Westchester Heartland 2M

First Floor Plan

PLAN NAME  
WESTCHESTER  
NPC CHILD NUMBER  
1852.302

SHEET  
A1  
4-1.1

SECOND FLOOR PLAN - 4" EXTERIOR WALLS

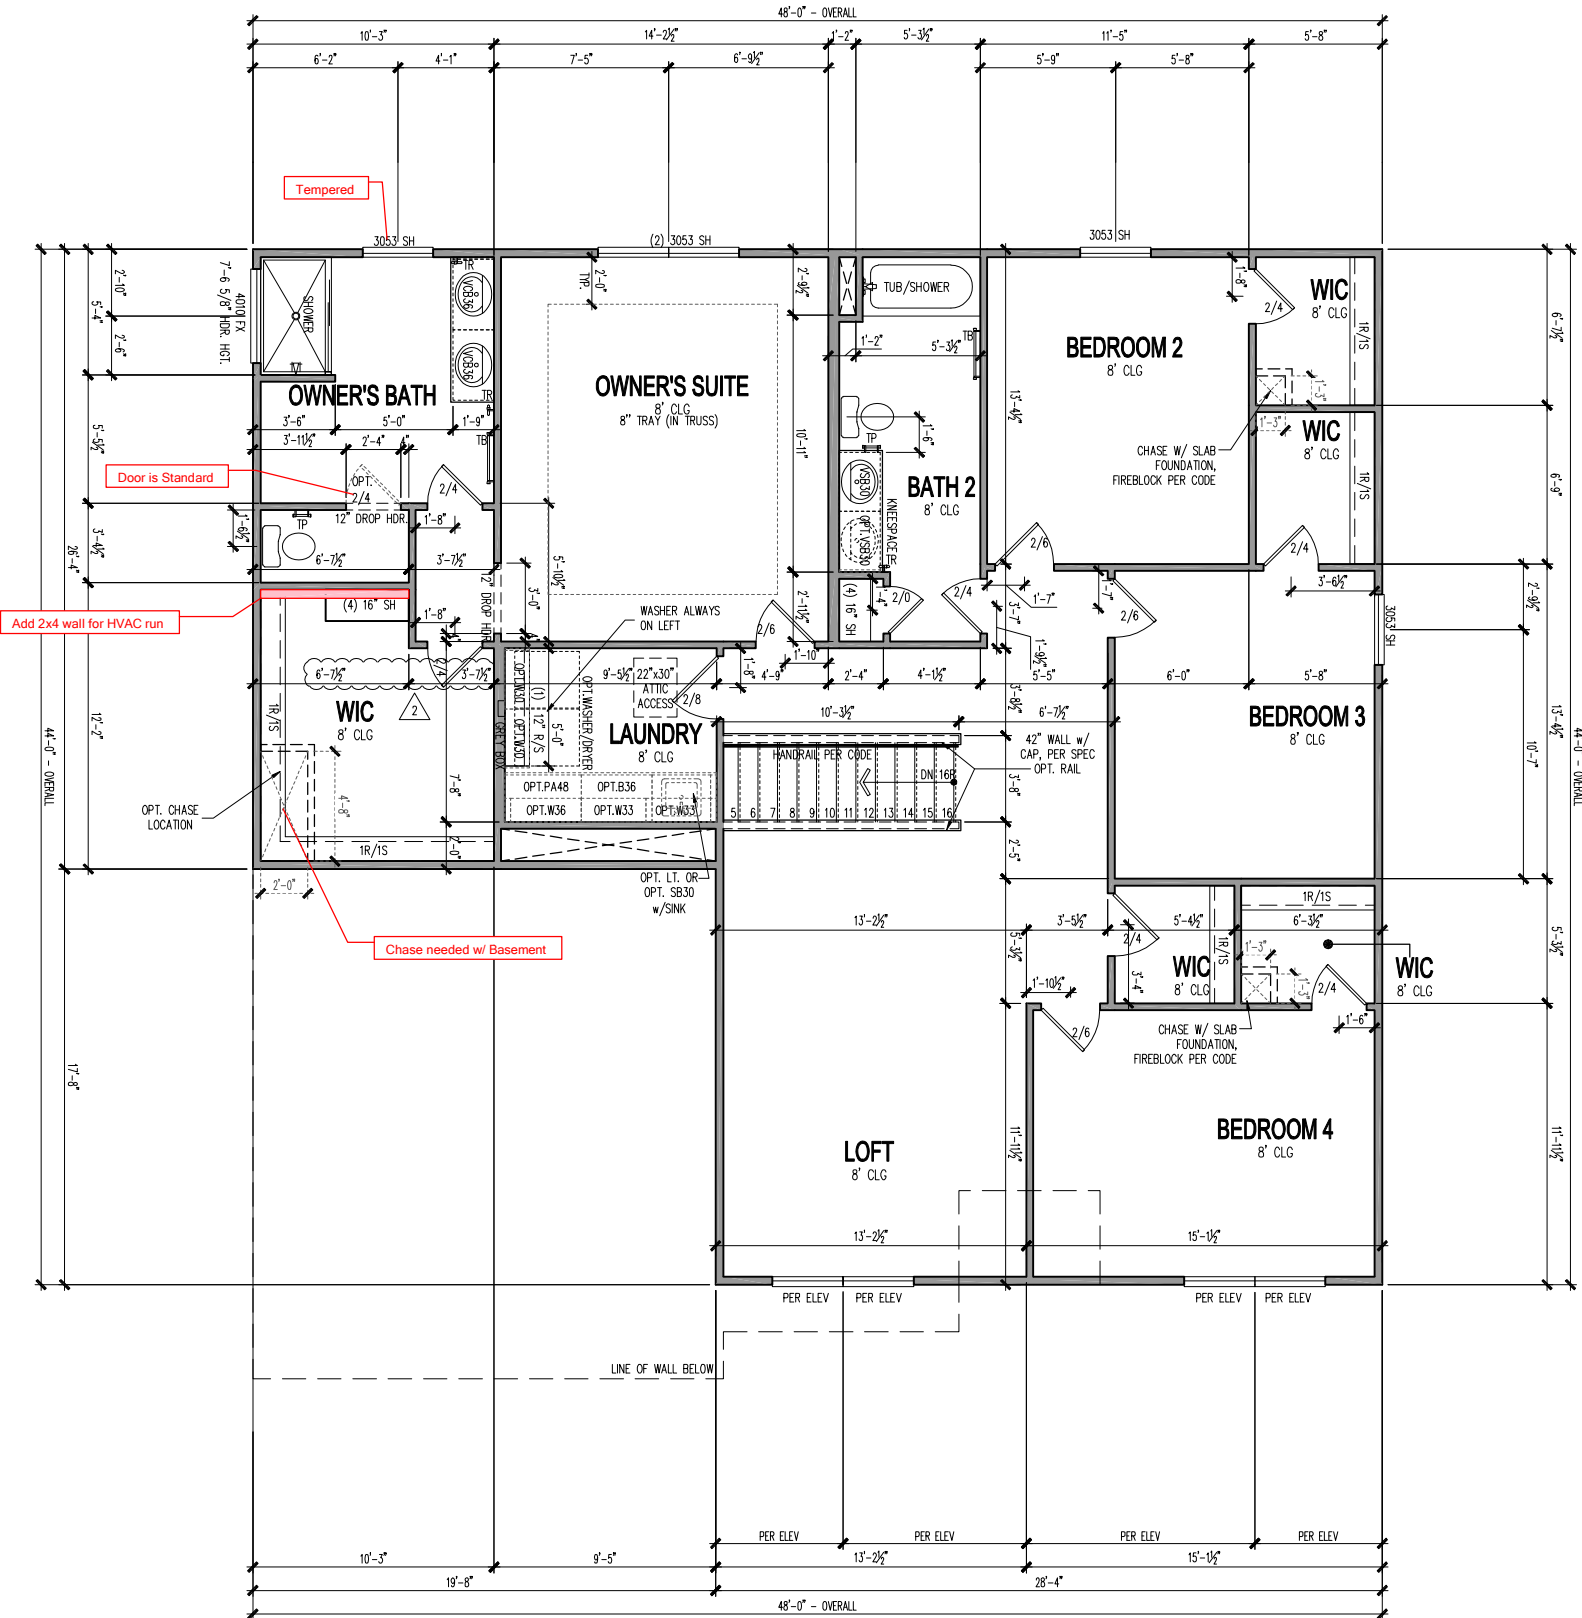
Chase needed w/ Basement

Make 2x6 Wall for  
Plumbing Lines/Drains
